Moon Brook Impairment Status

February 25, 2009 Briefing

This is how the Moon Brook and Tenney Brook flow duration curves are Presented in the Draft TMDL

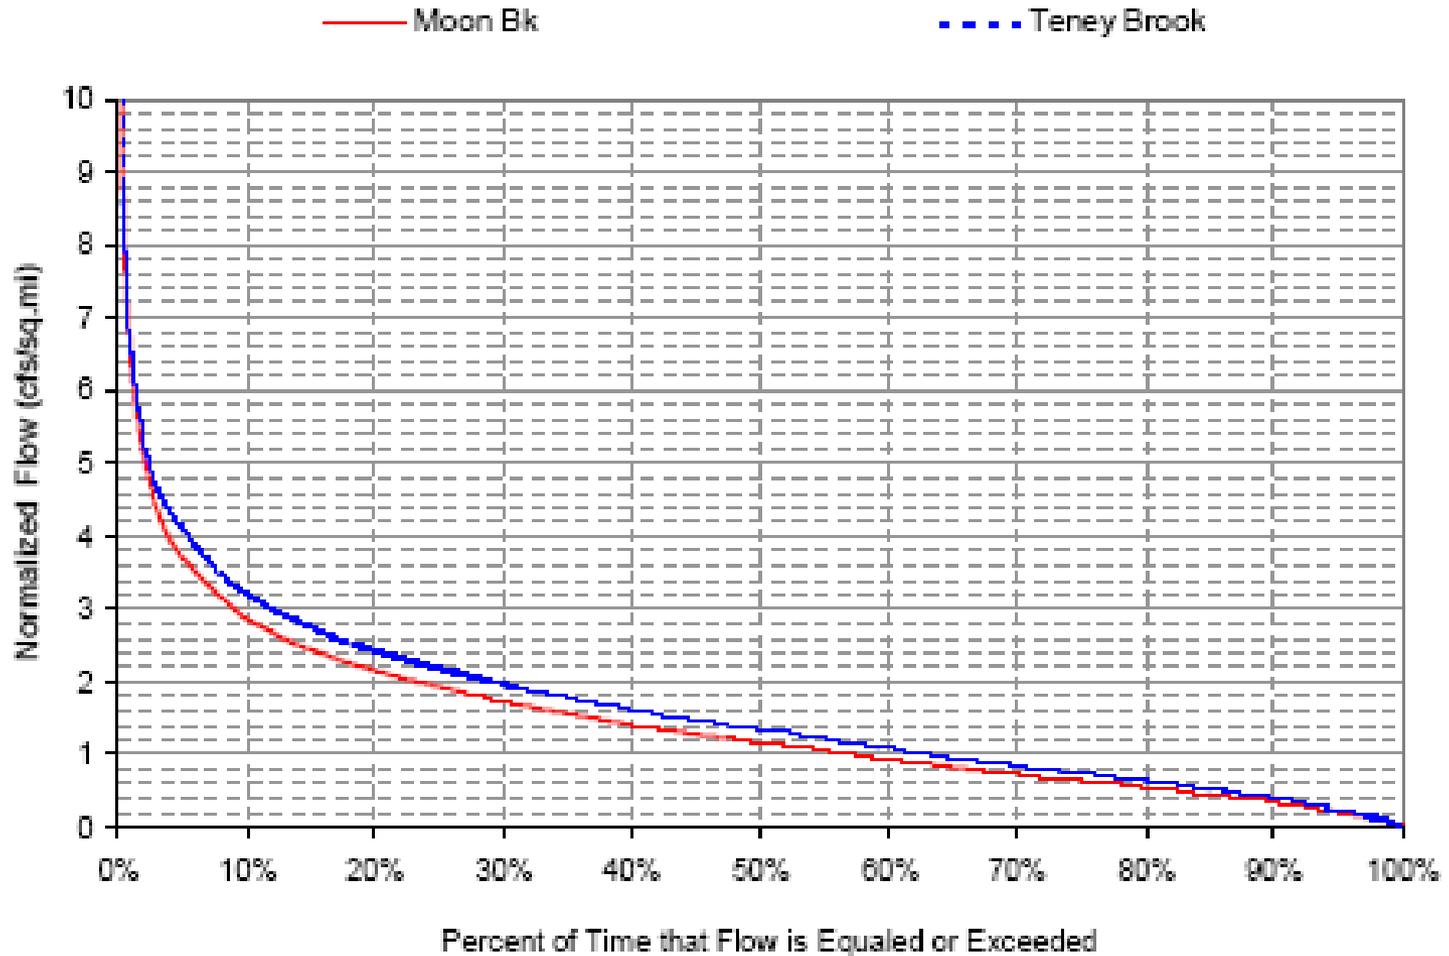
- Reference stream flows are arbitrarily reduced by 5%; but for this adjustment, the curves would be indistinguishable.
- Both lines are presented as precise curves; this is not accurate.
- In reality all key inputs to the model are estimates and the model itself is an approximation.
- A more accurate representation of these curves would be as shown in the next slide:

Moon and Tenney Brook flow duration curves with uncertainty indicated.

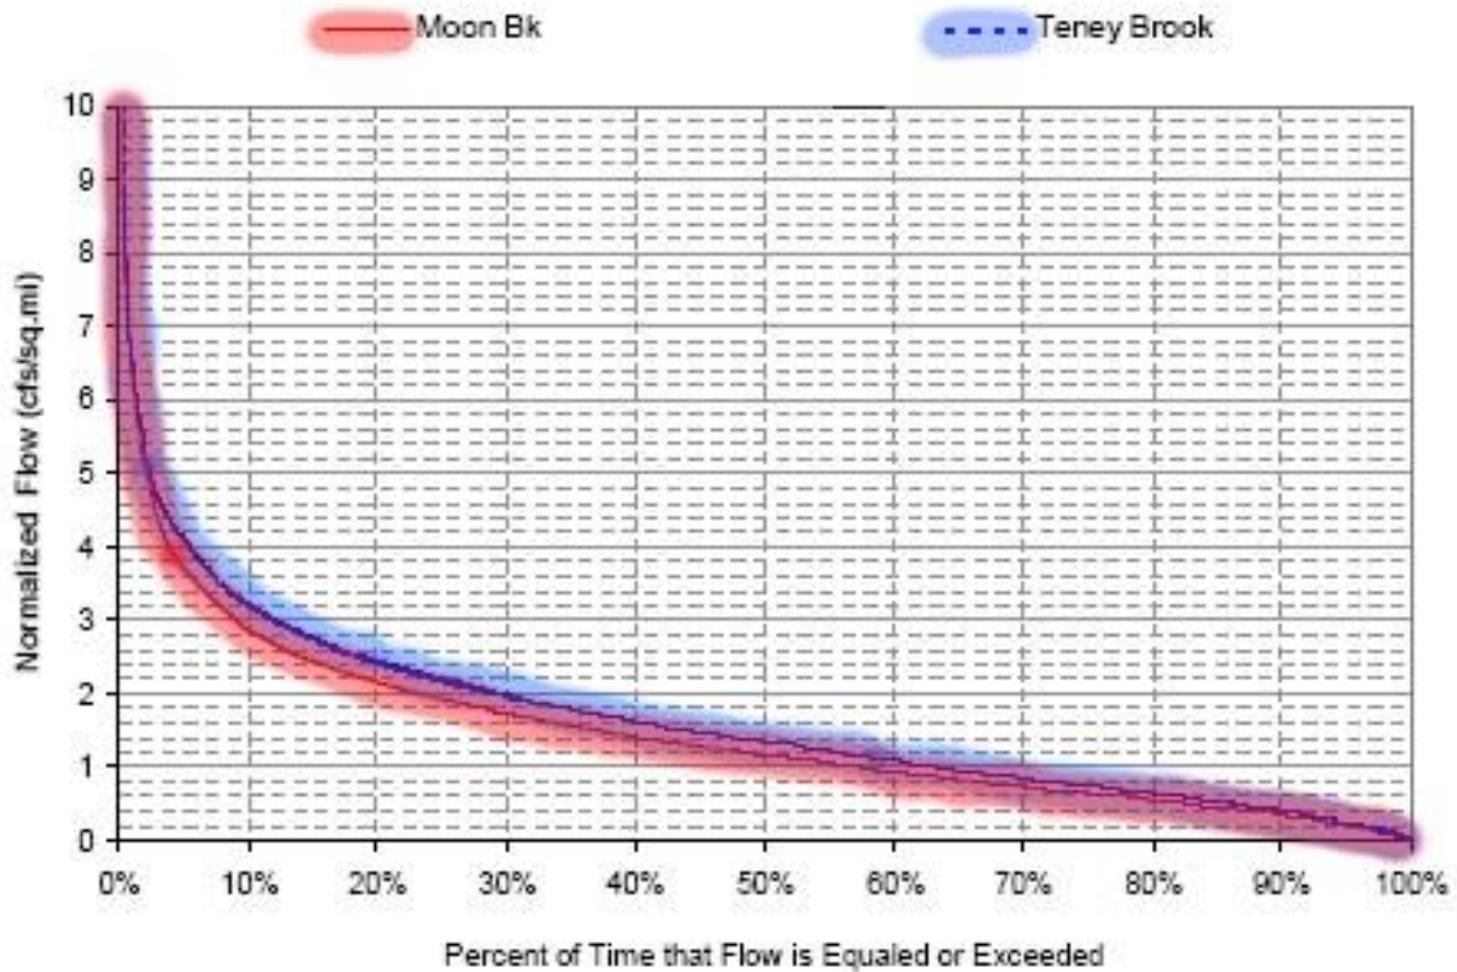
- DEC has not calculated or represented the confidence intervals around the Moon Brook and reference stream curves;
- CoR believes that when these uncertainties are included, there will be no statistical difference between the curves along their entire length.

This is the high flow portion of the duration curve from the draft TMDL.

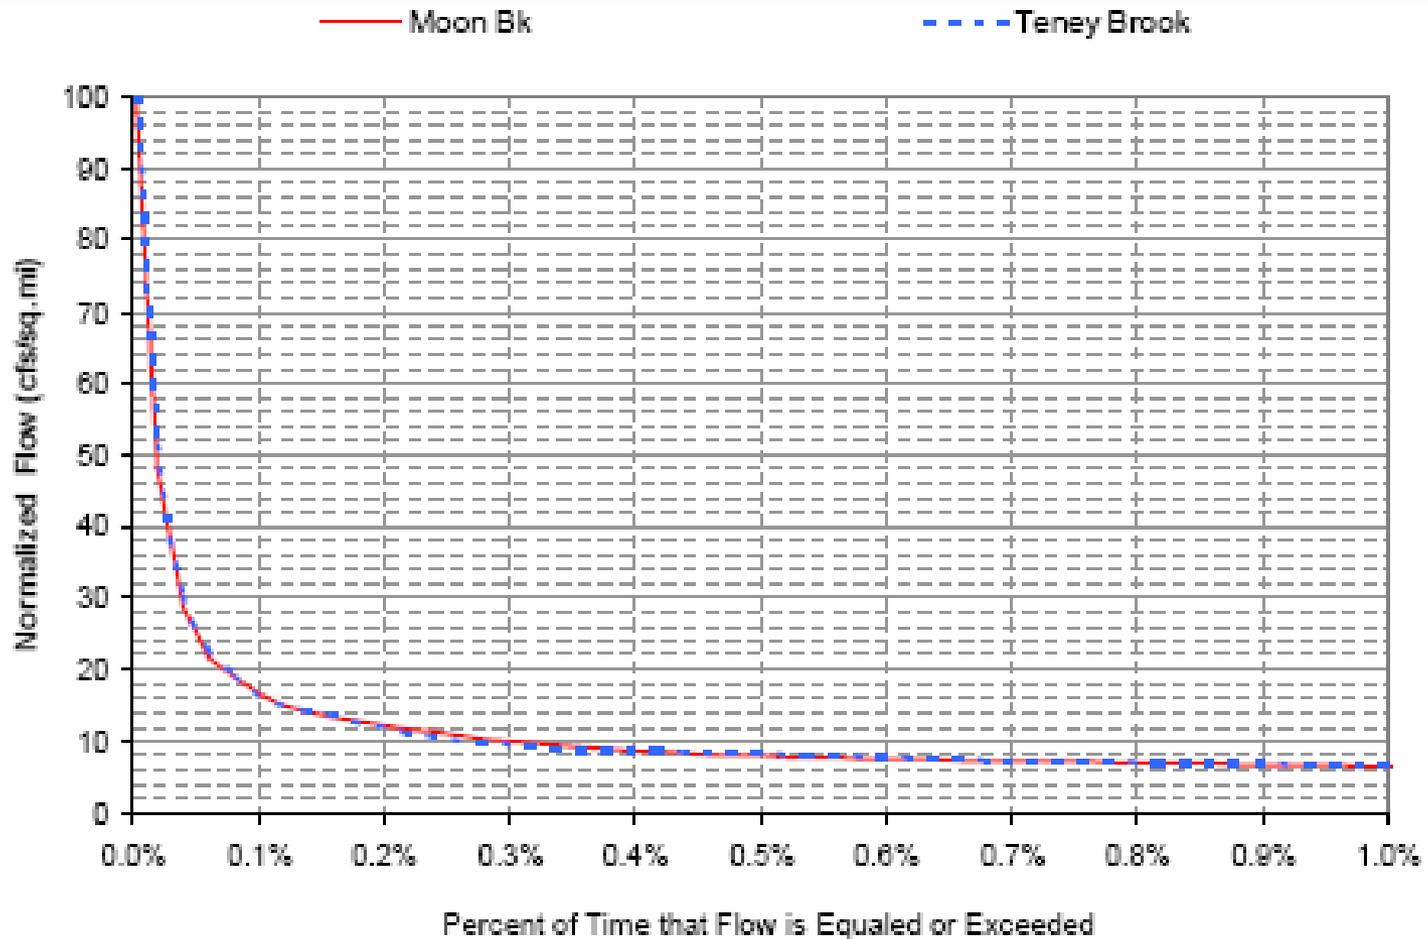
- Even without confidence intervals or corrections for combined sewer diversions, there is no distinguishable difference between the reference stream and Moon Brook for the critical high flow condition.
- **When all corrections are made and confidence intervals included, we believe the P8-UCM model will show that from a stormwater discharge perspective, Moon Brook *should not be impaired.***

Moon Brook Temperature 2007 With 2 Day Trend Line

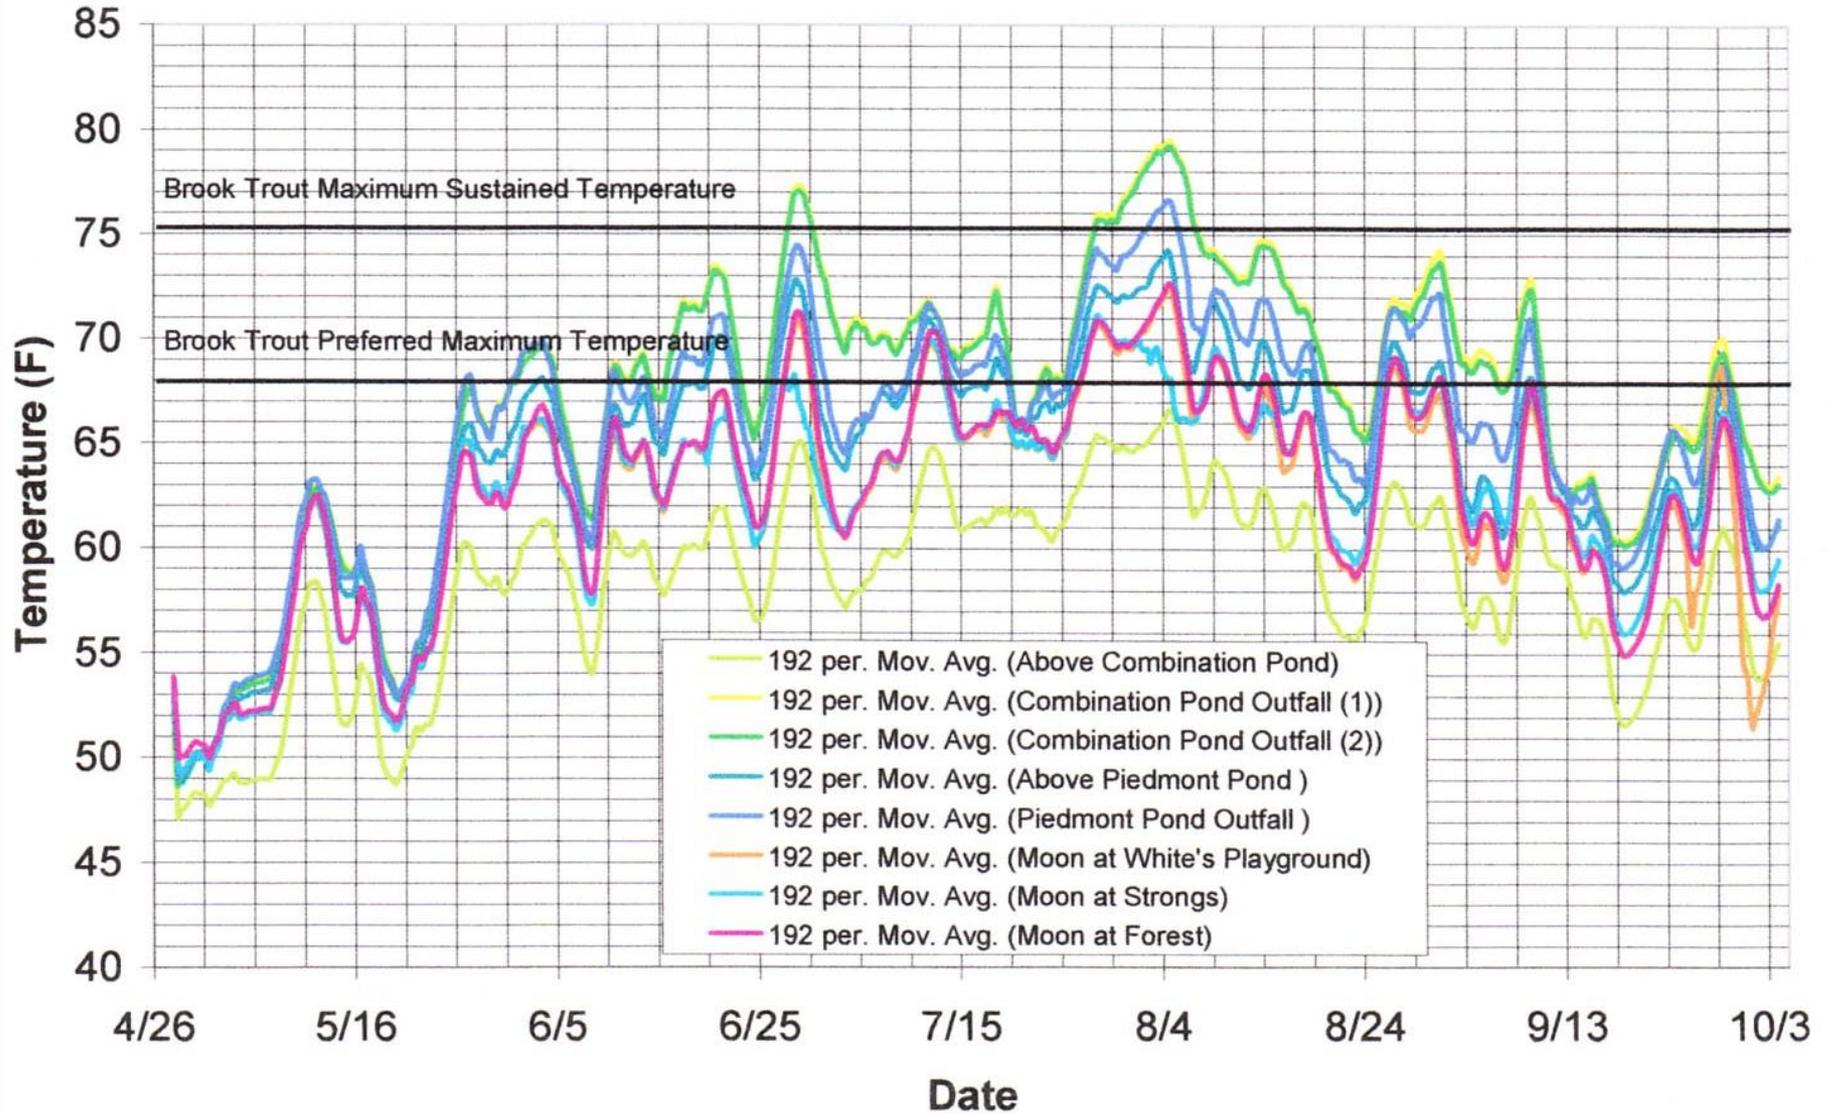
- Comprehensive in-stream temperature measurements conducted by CoR between 2005-2007.
